ADDENDUM

Date Issued:	July 17, 2024
Project:	Canyon Surgical Associates Clinic Remodel 5171 Cottonwood Street #650 Murray, Utah 84107
Addendum Number:	1

Canyon Surgical Associates
Clinic Remodel
South Office Tower - Level 6

NJRA Project # 24002.00
Construction Documents June 27, 2024
1 Addendum 1 July 17, 2024

DEFERRED SUBMITTALS

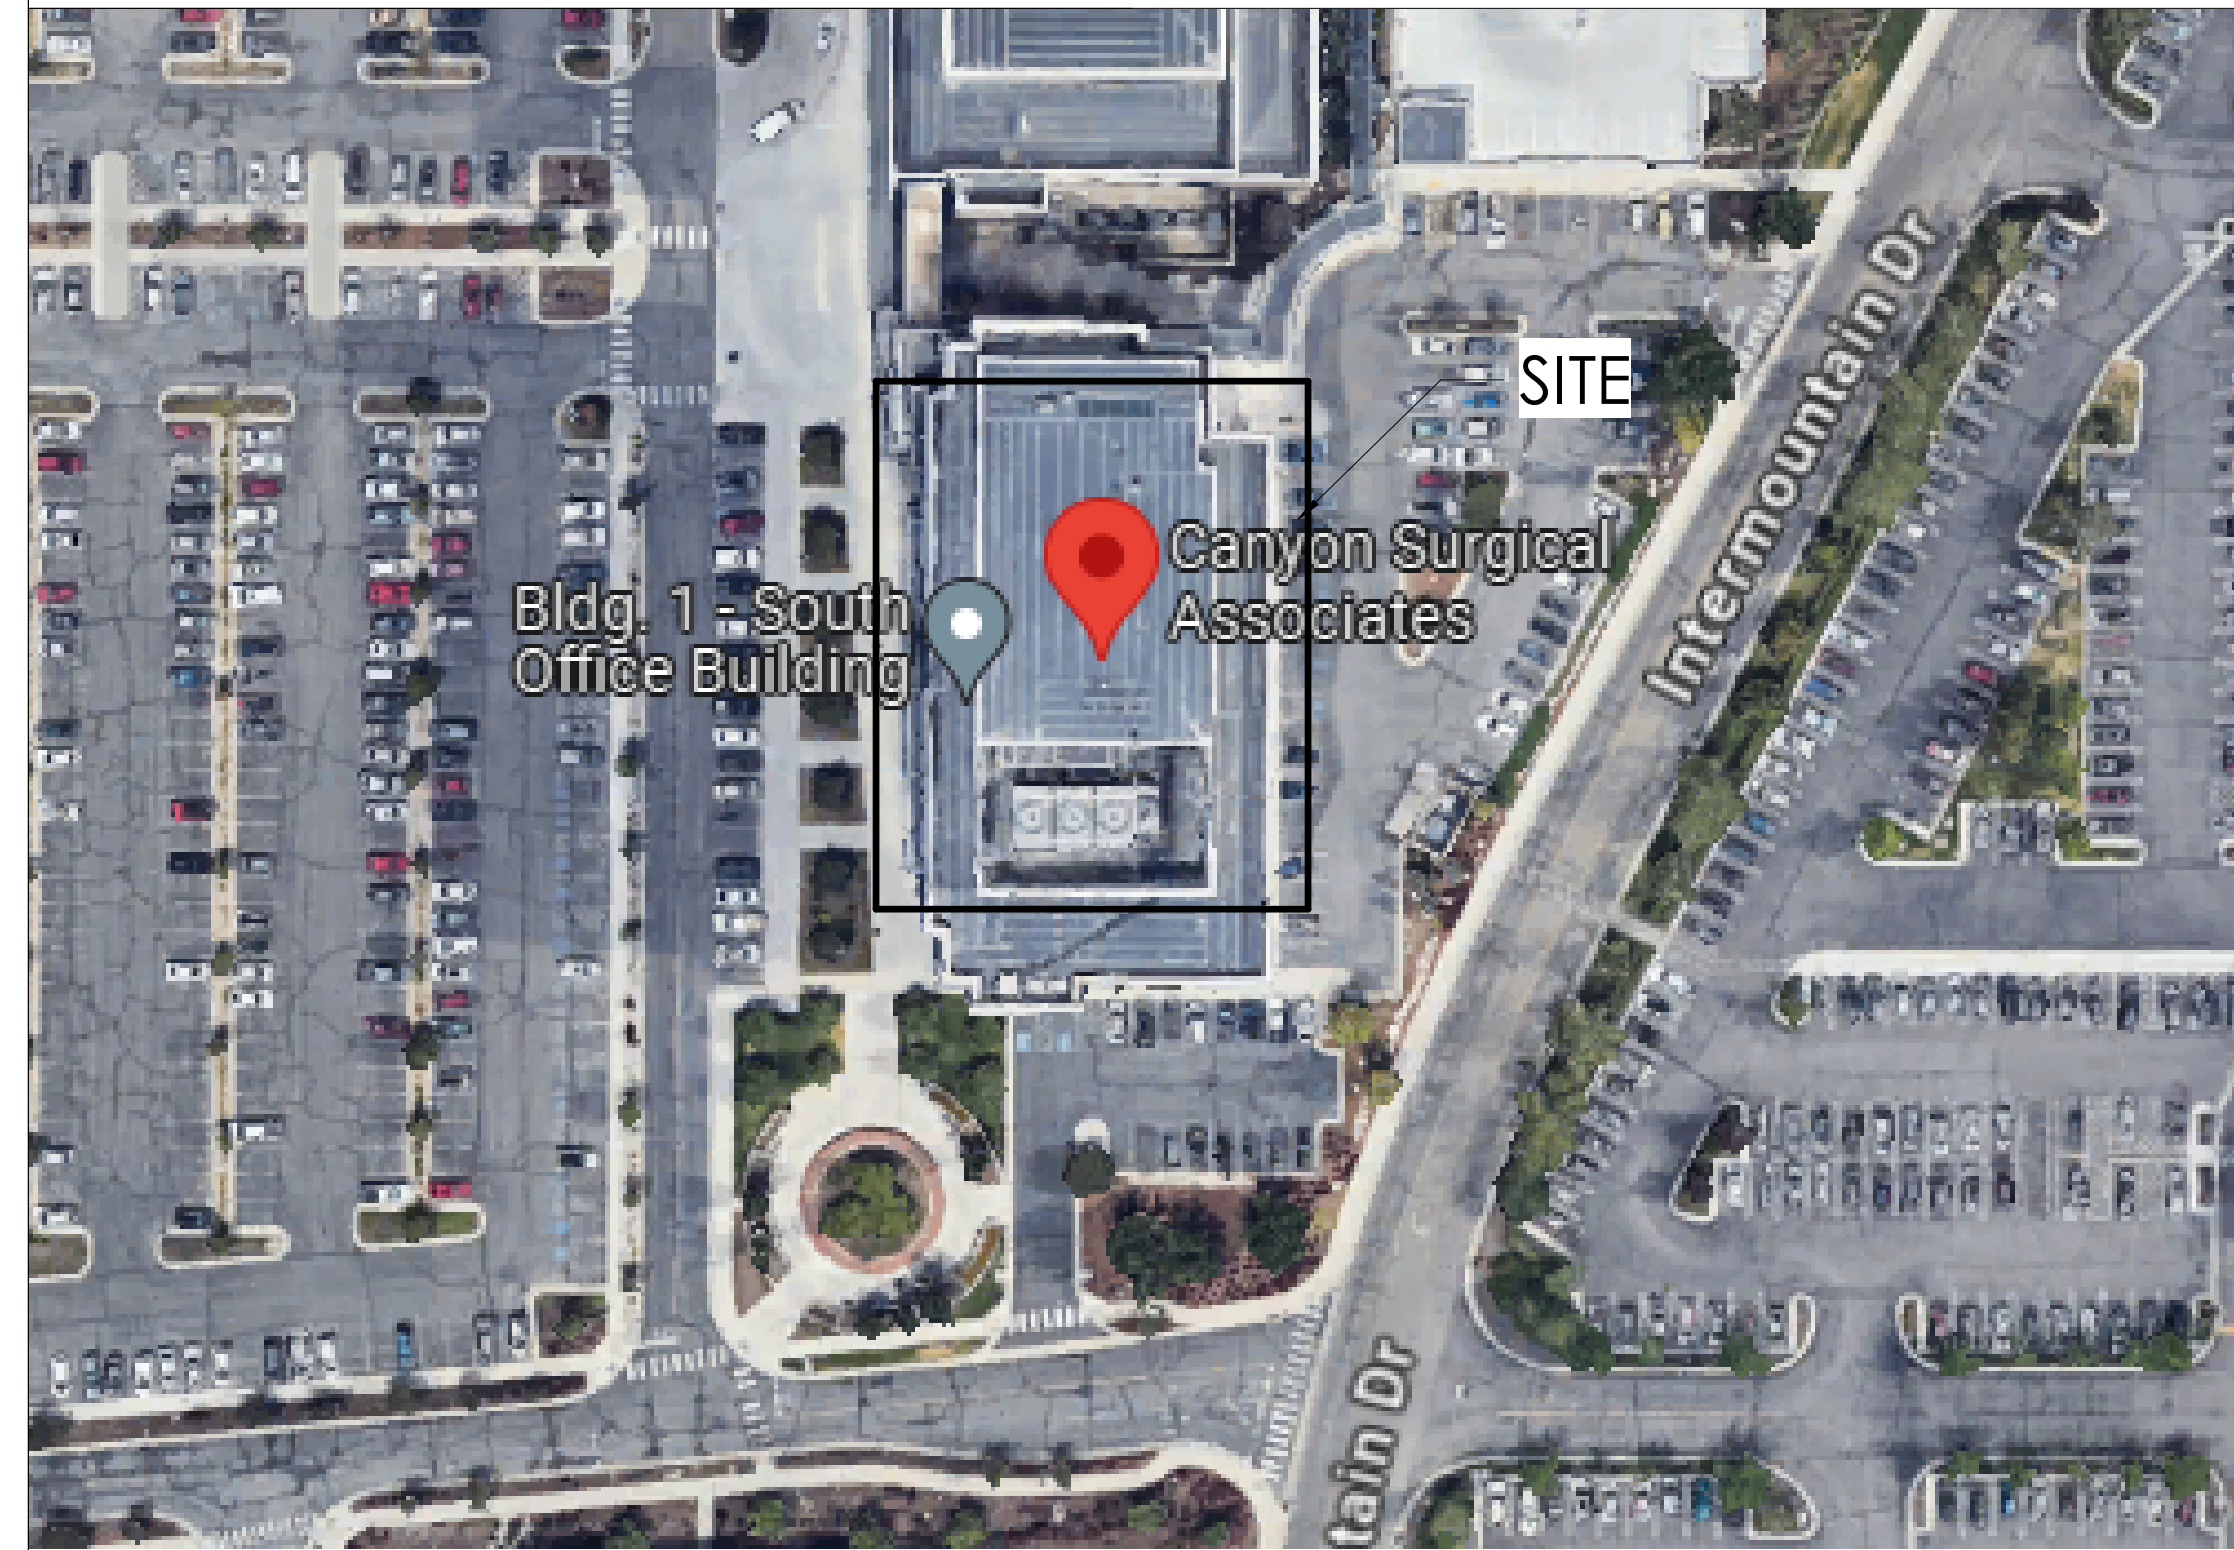
Sheet Number	Drawings
Architectural Drawings	
G002	Update allowed deferred submittals
A503A	Update seismic pod requirements to 144 sq. ft. on detail 7/A503A

THE CONTRACTOR SHALL SUBMIT THE FOLLOWING TO THE BUILDING OFFICIAL FOR REVIEW WITH AN ACCOMPANYING LETTER FROM THE ARCHITECT STATING THAT THE CONTENTS OF THE SUBMITTAL ARE IN CONFORMANCE WITH THE DESIGN. WORK RELATED TO THE DEFERRED SUBMITTAL IS NOT TO COMMENCE UNTIL THE BUILDING OFFICIAL HAS APPROVED THE SUBMITTAL.

- DETAILS AND ENGINEERING CALCULATIONS FOR THE FIRE SPRINKLER AND FIRE DETECTION SYSTEMS, WHICH ARE TO BE DESIGN-BUILD BY THE CONTRACTOR TO COMPLY WITH NFPA 13 AND SHALL INCLUDE:
 - FIRE ALARM PLANS (INCLUDING CO DETECTOR LOCATIONS)
 - AUTOMATIC FIRE SPRINKLER PLANS

Proposed rough phasing diagram:

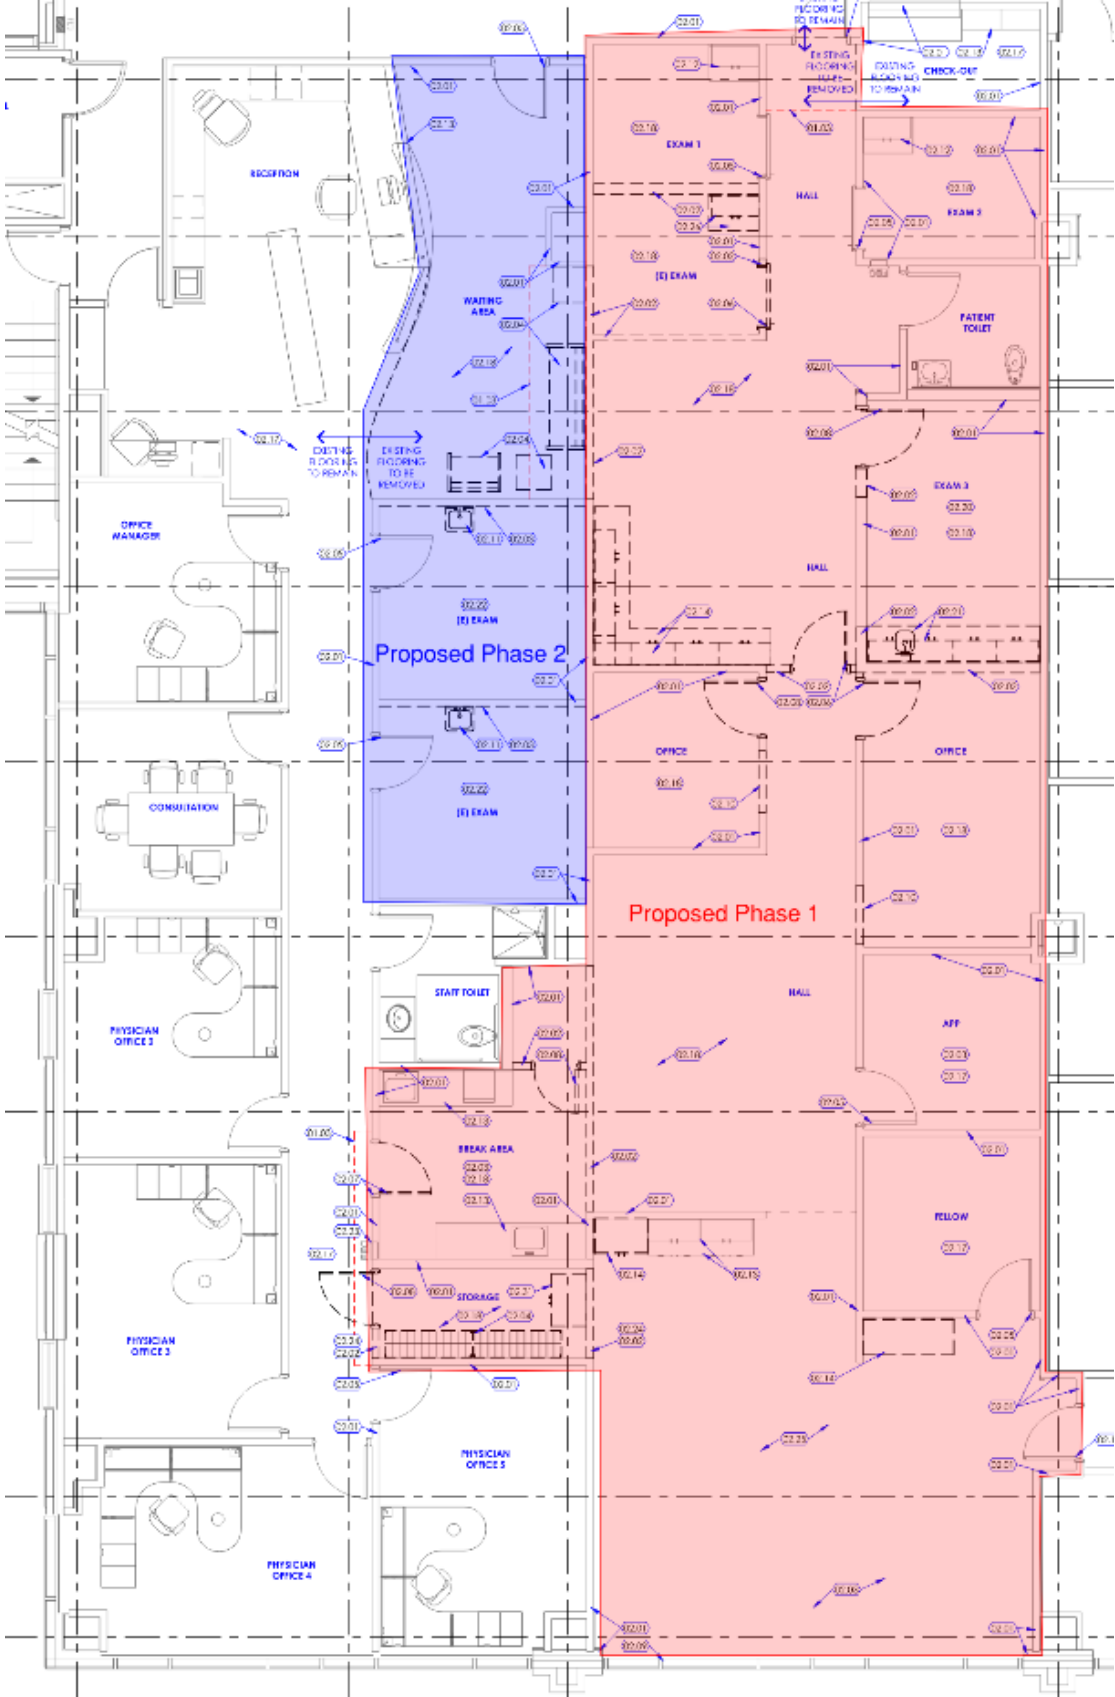
Is this work having to be done in phases, or are we able to take all of the areas at the same time? Is this work able to be done during normal working hours (7-5), or is the owner wanting it to be done nights and weekends?

The majority of the work is in unoccupied space. Currently on the north side the small check-out that does not have any work in the scope is the only space occupied, and on the south side the clinic is fully occupied but the rooms within the scope of the construction are the existing waiting, break area and storage room adjacent, and the two exam rooms that are becoming offices. They would prefer to have access to the check-out through construction and coordinating finish work that allow access to that space, but may make an exception for cost reduction. There will have to be some coordination with the owner that may require either phases or off hours work to be able to use the clinic while work is taking place in the existing waiting and use of the exam rooms until the new exams are finished. Contractor can suggest project construction plan and schedule, but I would anticipate that completion of the north side and the break area and storage room removal for a hall would all be a first phase, then a second phase for removing the sinks from the existing exams for the offices and the finish replacement in the existing waiting room so that the south side of the clinic can function until the new exams are completed and have a small workflow coordination to use the north side access while the south side is completed. The owner has not yet but may request partial access to the break area in the proposed scenario phase one. I would anticipate that the majority of the work could be normal hours with the typical 72 hour notification and approval for specified activities from the project manual. In addition to the clinic area, off hours work and cleaning will need to be coordinated with Intermountain Health for above ceiling work needed on the 5th floor and/or activities that cause exceptional disruption to adjacent occupants in the facility. Luke Love will provide the coordination from Intermountain. See proposed rough phasing diagram at the end of this document.
